PROJECT NAME: Murphy Cadotte / 1780

VENDOR NAME: Canadian Water Technologies / 1780-005

DOCUMENT
DESCRIPTION: Process & Instrumentation Diagram

VISTA MURPHY CADOTTE -1780
PROCESS & INSTRUMENTATION DIAGRAM
WATER TREATMENT PACKAGE PKG-6000

DRAWING TITLE
**BUILDING
FAN AND HEATER
LAYOUT**

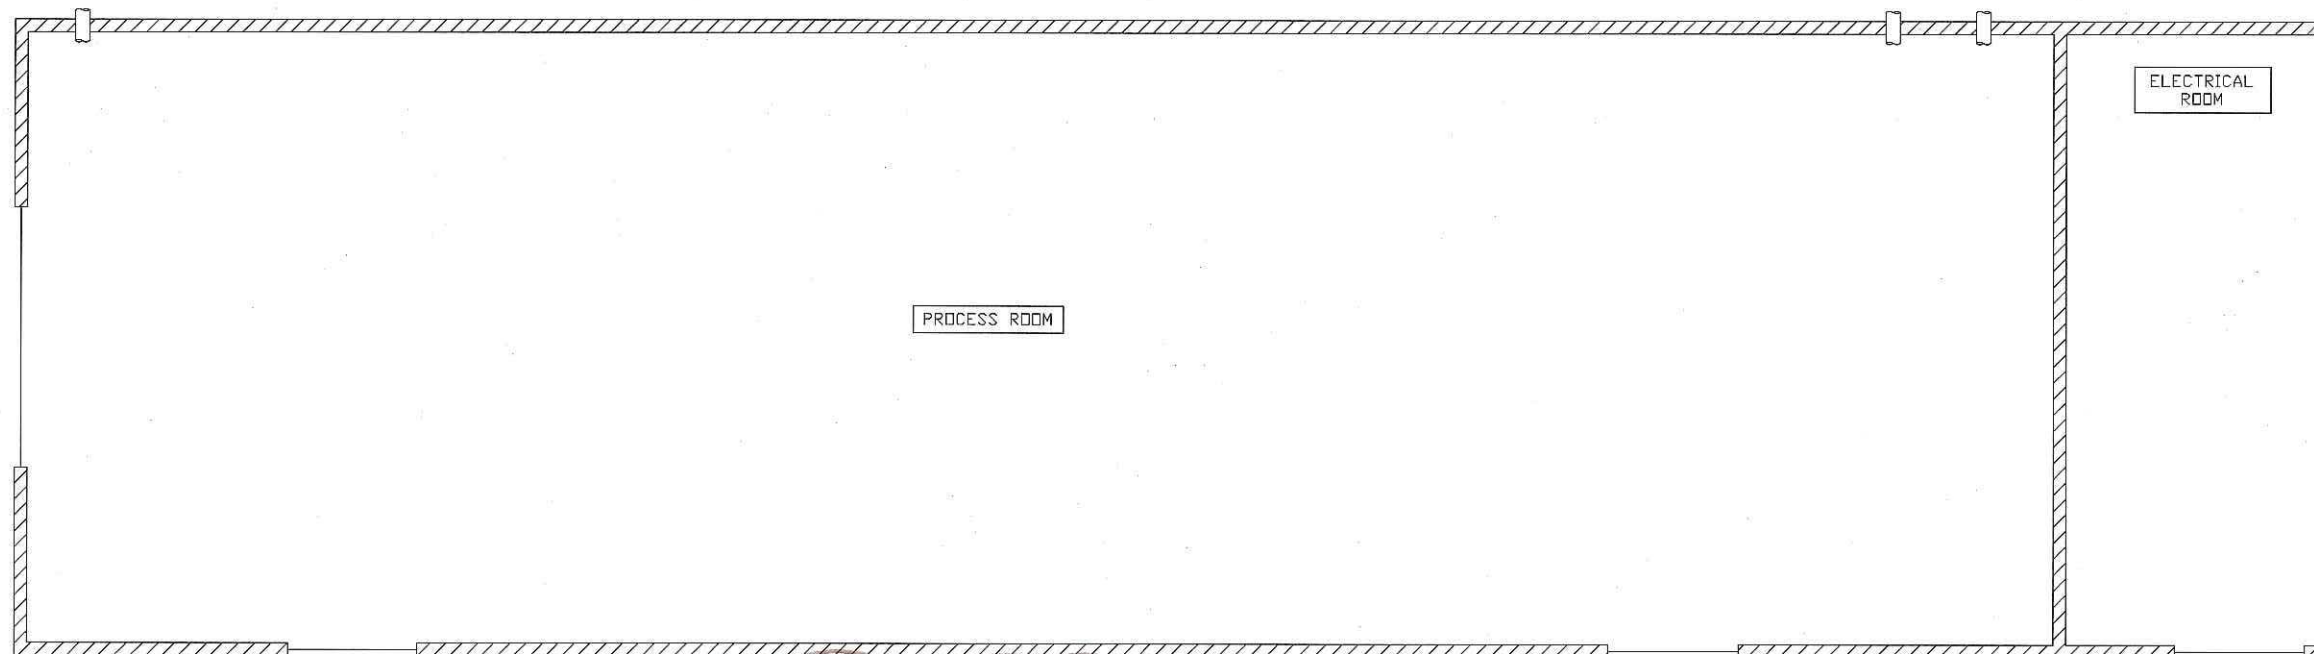
PROVIDE FAN & HEATER LOCATIONS & BOM

ALL DWG'S MUST HAVE DIMENSIONS IN MM &
PROPERLY SAID ON DWG & DWG TO BE TO SCALE

Drawing requires completion

DOCUMENT
DESCRIPTION: Building Panel Location Layout

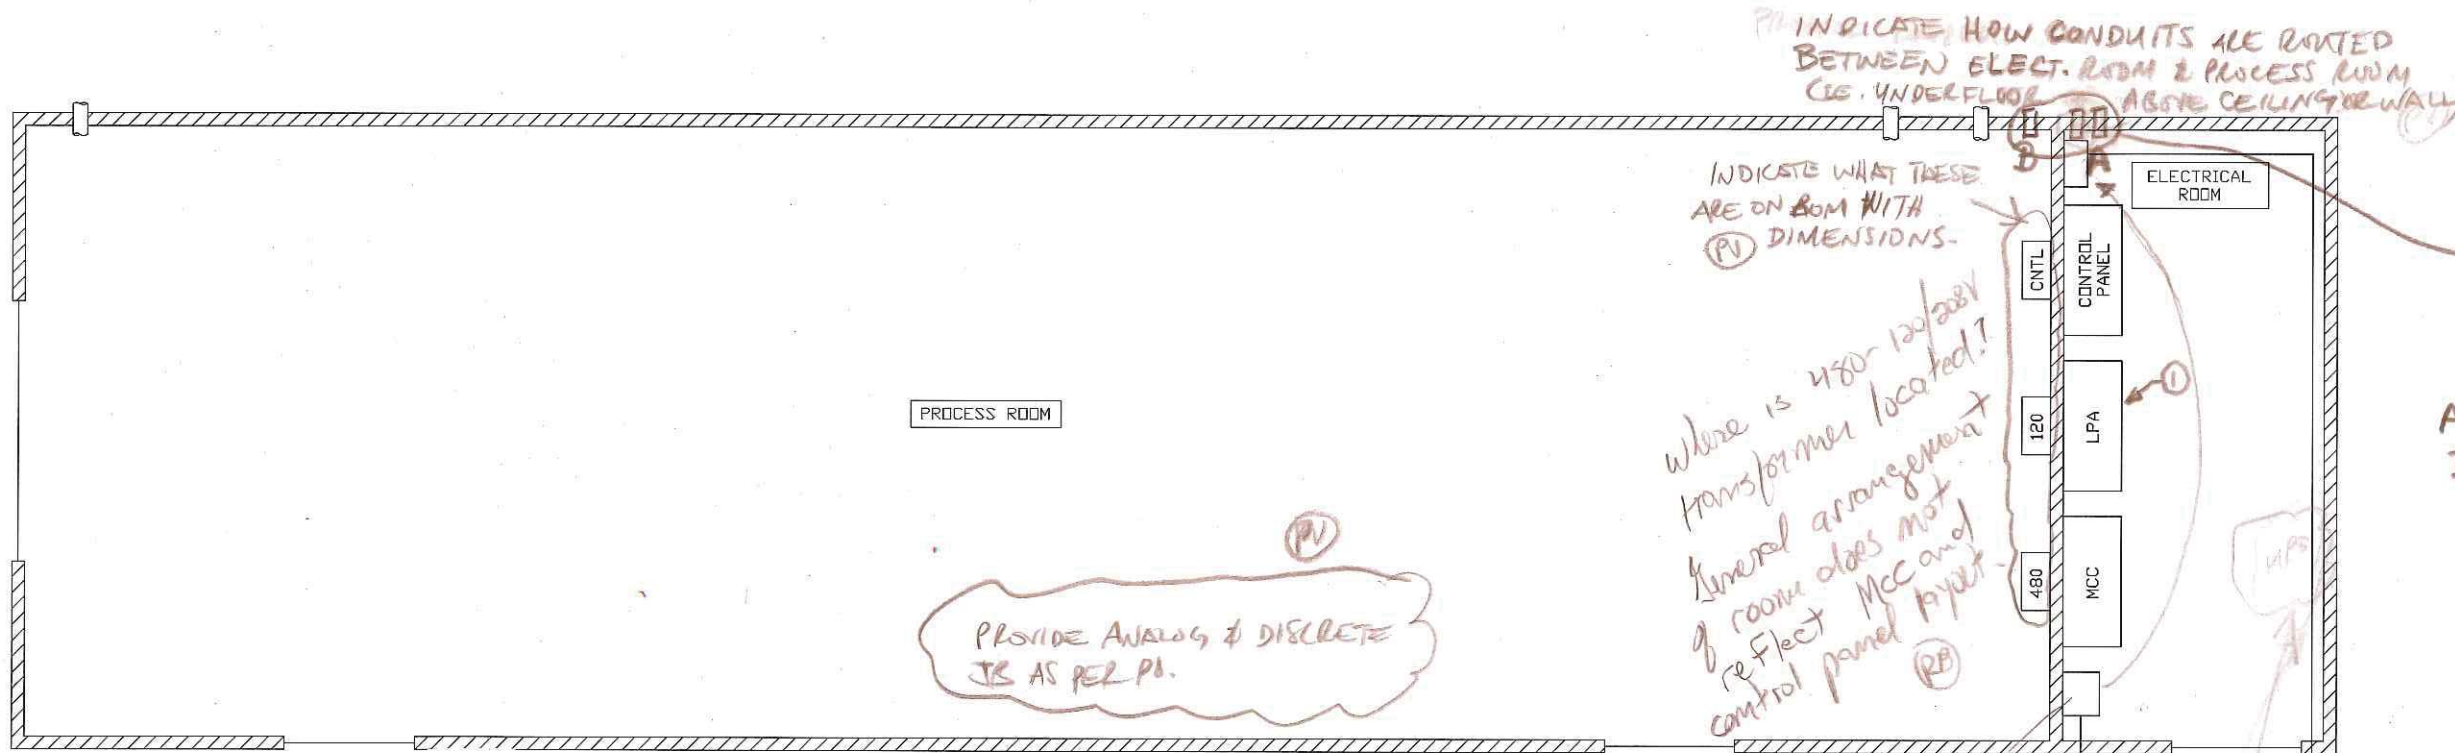
VENDOR TO COMPLETE.
(PV)

PROVIDE BOM, DIMENSIONS, ETC
OF OTHER EQUIPMENT SHOWN
ON DWG.
(PV)

PROVIDE ANALOG & DISCRETE
I/O AS PER PI.
(PV)

PROVIDE THREE
CONDUIT SLEEVES
THROUGH WALL FOR
CUSTOMER @ 1625mm A.F.F.
A 1- 3" sleeve c/w bushings
B 1- 2.5" sleeve c/w bushings

ALL DWG'S MUST HAVE DIMENSION IN MM
& PROPERLY SHOWN ON DWG & DWG TO BE
TO SCALE
(PV)

Please + possible to
relocate to other
end of wall?
(RB)

BUILDING
INSTRUMENTATION
LAYOUT

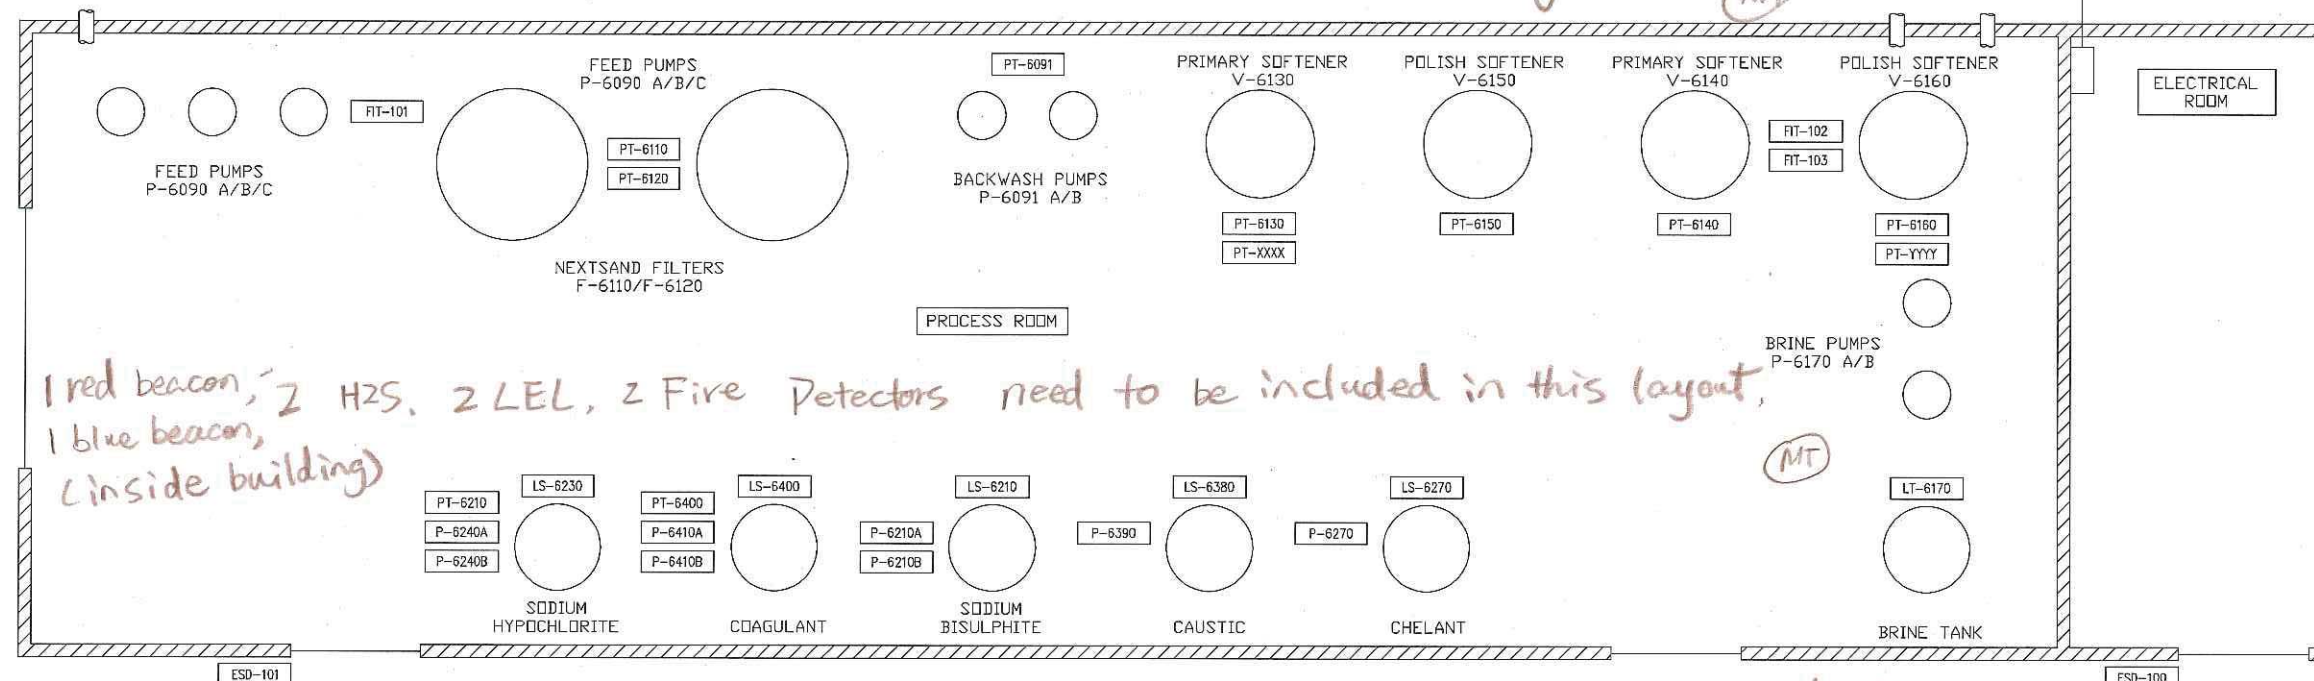
Locate water drain tank pump
P-6280

ALL INSTRUMENTS TO
MEET CLASS 1, ZONE 2
GROUP 1A, 1B AREA
CLASS

please provide BOM for all the instruments listed in this layout.

1 red beacon, 2 H2S, 2 LEL, 2 Fire Detectors need to be included in this layout,
1 blue beacon,
(inside building)

The following I/O points will be hard wired between main plant PLC and this building.

- ① Remote ESD from main plant PLC to this building PLC
- ② permissive signal (plant ready) from main plant PLC to this building PLC
- ③ Water treatment package trip alarm from this building to main plant PLC
- ④ 2 H₂S, LEL, Fire Detectors wired to main plant PLC. (preferred 24VDC instead of 120VAC)
- ⑤ 1 red beacon, 1 blue beacon wired to main plant PLC (24VDC)
- ⑥ exhaust fan start/stop contact wired to main plant PLC
- ⑦ Outside ESD push buttons wired to main plant PLC

DRAWING TITLE
BUILDING
HAZARDOUS LOCATION
LAYOUT

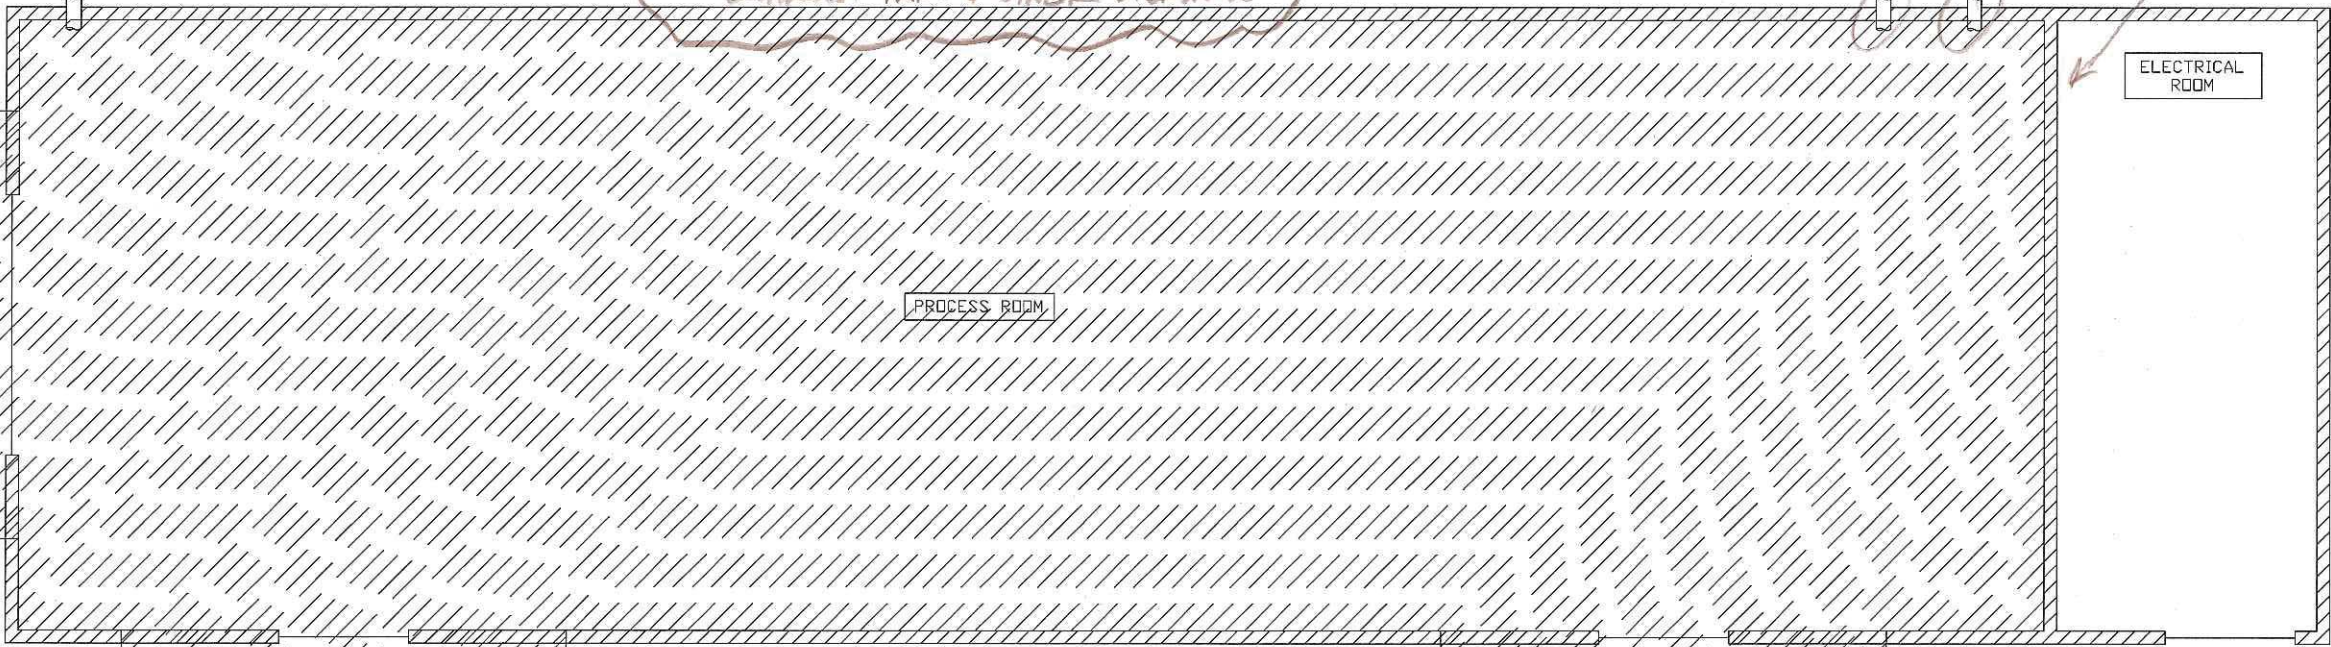
MUST BE ZONE CLASSIFIED,
& SHOW GR IIA & TEMP. TRB (AS METHANE GAS IS PRESENT IN SOURCE WATER WELL)

ALL ELEC. DWG'S TO BE
STAMPED & SIGNED BY VENDOR
ELEC. ENGINEER AS PER PD.

WHAT ABOUT LEAKAGE THROUGH EXHAUST
FANS? SHOW LEAKAGES THROUGH
EXHAUST FANS & OTHER OPENINGS

LEAKAGE
OPENINGS?

MUST
PROVIDE A
FUGITIVE EMISSION
STUDY AS PER
API 505 AS STATED
IN PD.

THIS DWG IS NOT PER
API 505 STANDARD.
AREA CLASS DWG MUST
COMPLY TO API 505
STANDARD AS A MINIMUM.
